BRAIDWOOD NUCLEAR POWER STATION
RADIOACTIVE EFFLUENT RELEASE REPORT FOR 2007
UNIT 1 AND 2 (Docket Numbers 50-456 and 50-457)

ATTACHMENT 2

Summary of ODCM Changes

FIGURE 10-2
 SIMPLIFIED LIQUID RADWASTE
 PROCESSING DIAGRAM

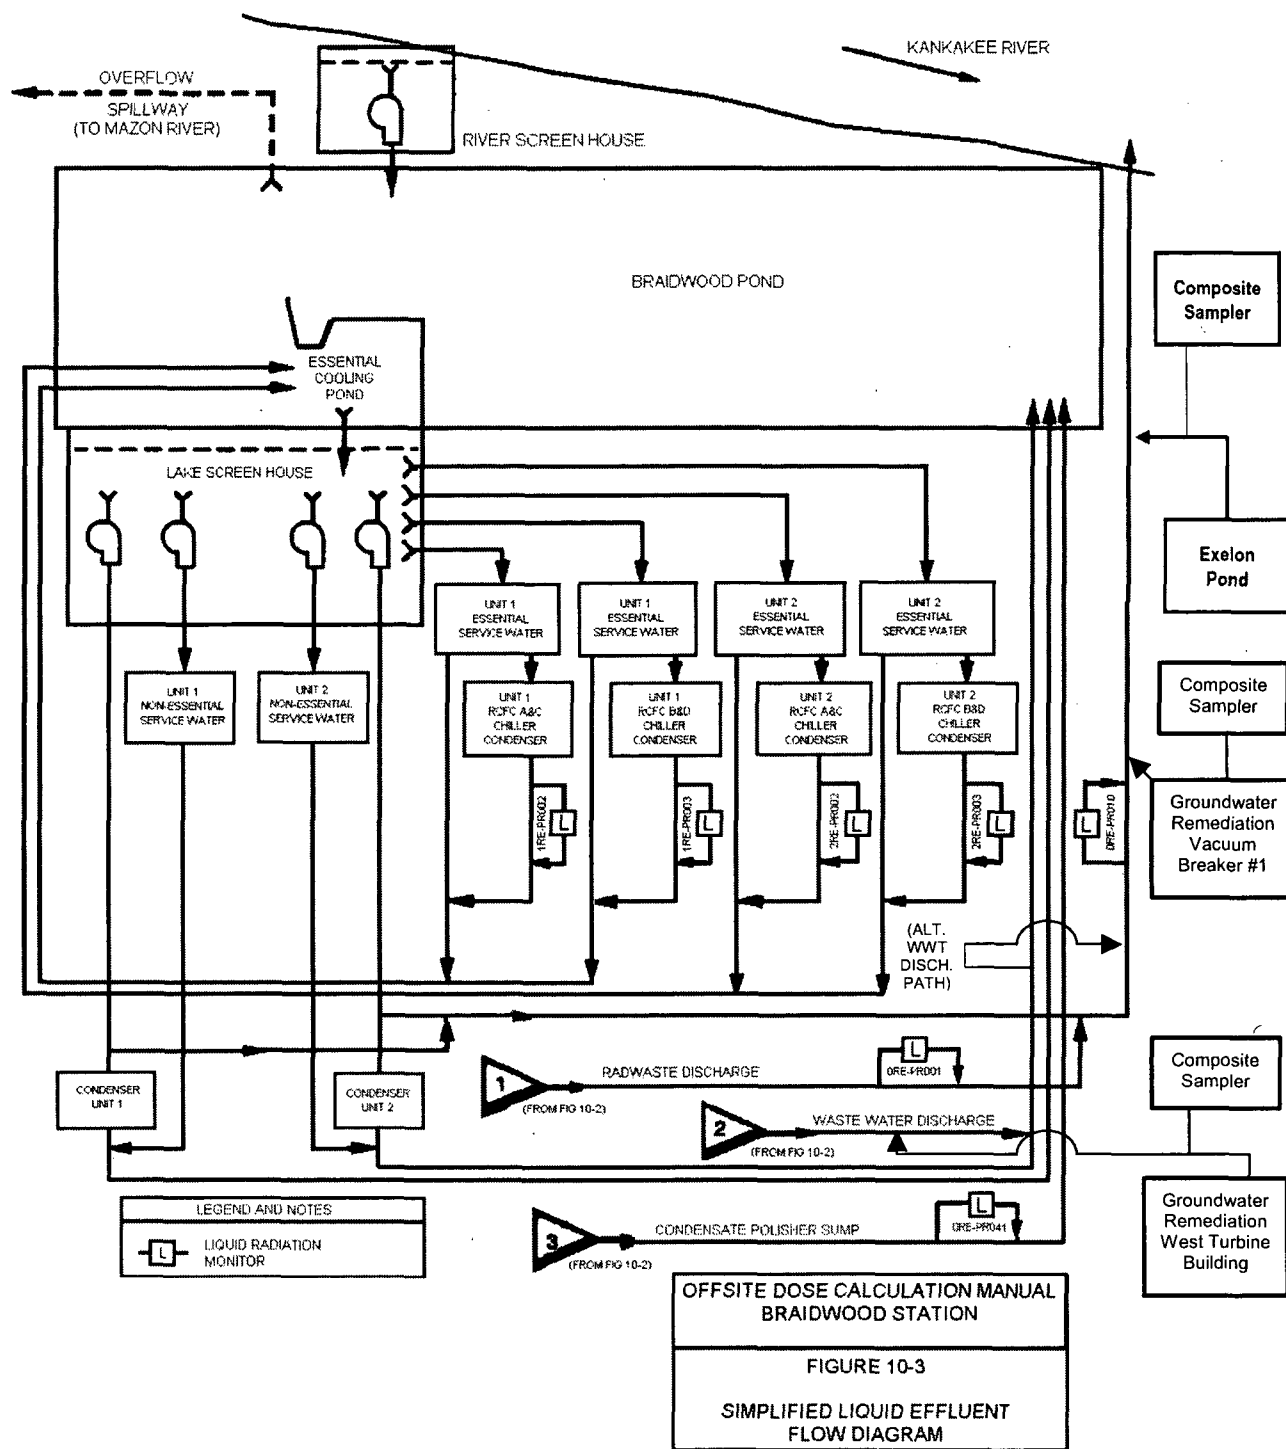
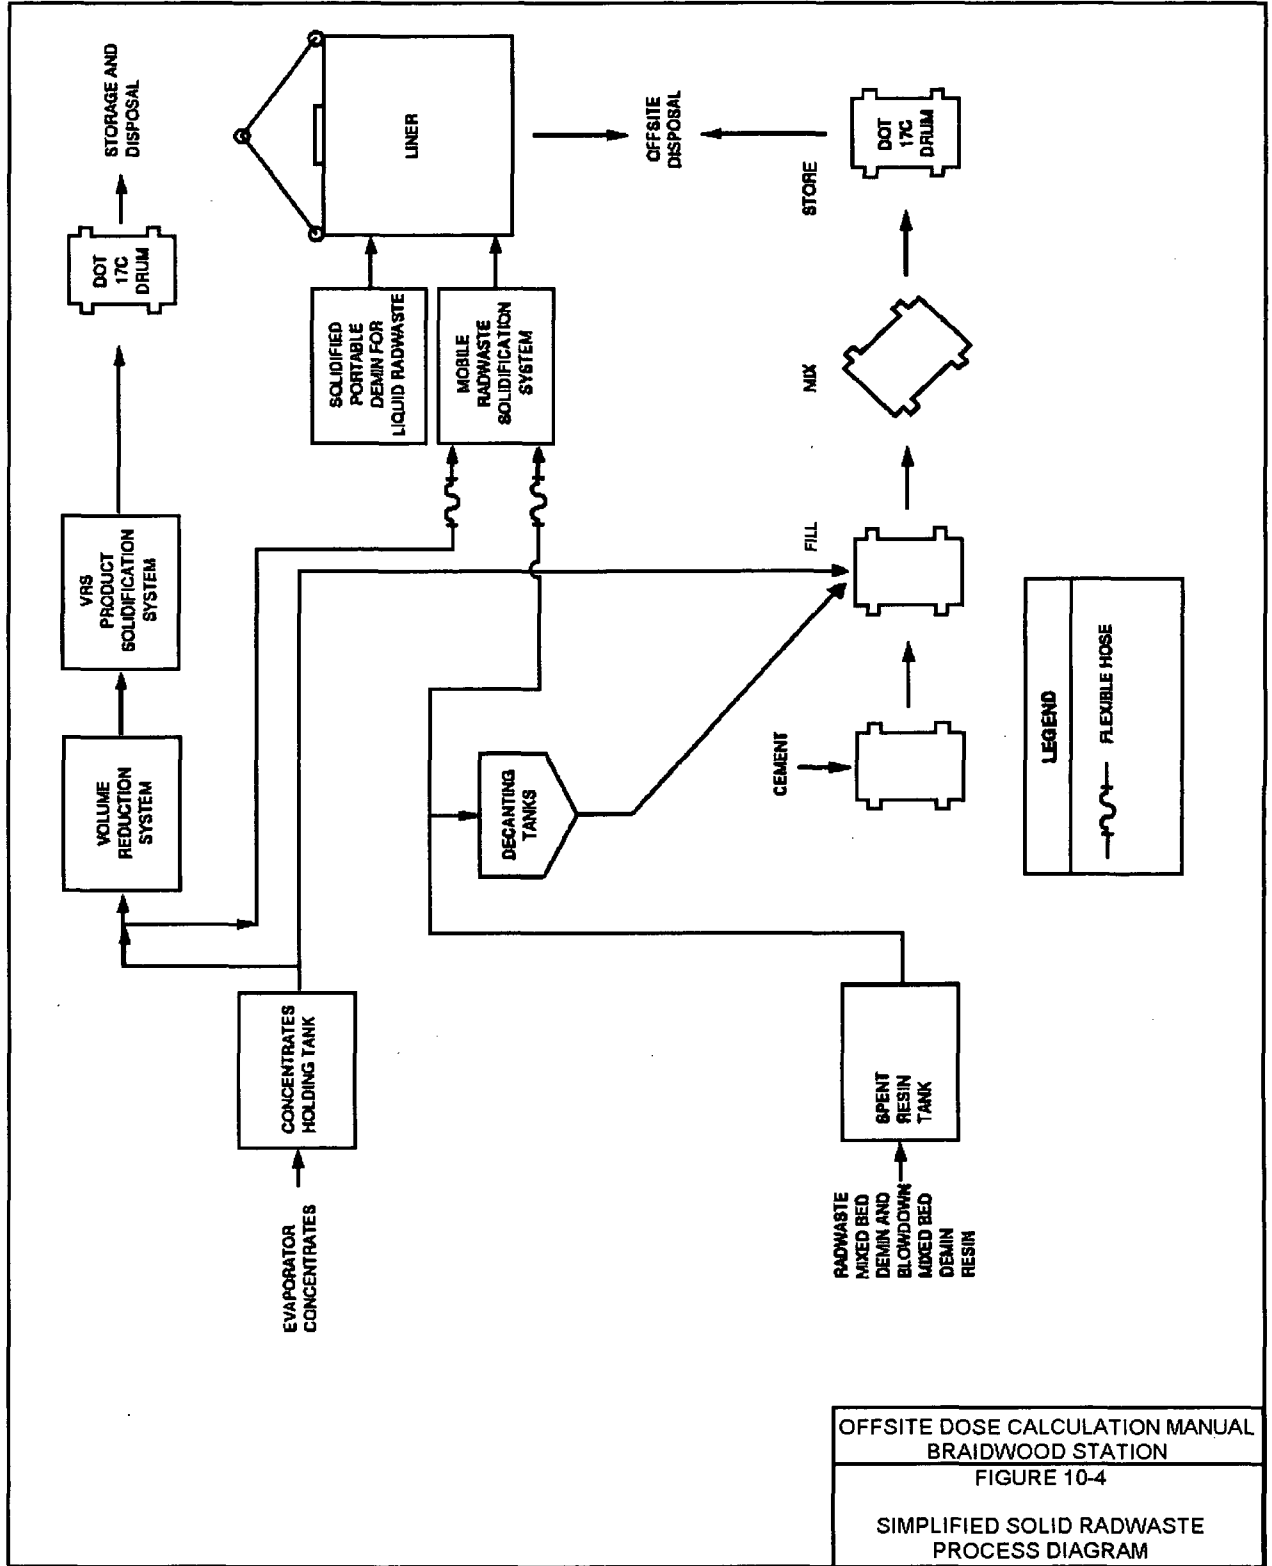
Item No.	(old) Rev. page No.	(new) Rev. page No.	Description of Change
1	166	166	Added description of composite samplers for the continuous release paths with statement that an alternate path exists for the discharge of Waste Water treatment. Changed title of section 10.2.1.2 to include continuous release paths.
2	175	175	Changed diagram to include the alternate path for WWT discharge. Added note for release tank to Circ Water Blowdown (see Fig 10.3).
3	176	176	Changed diagram to include alternate path for WWT discharge.
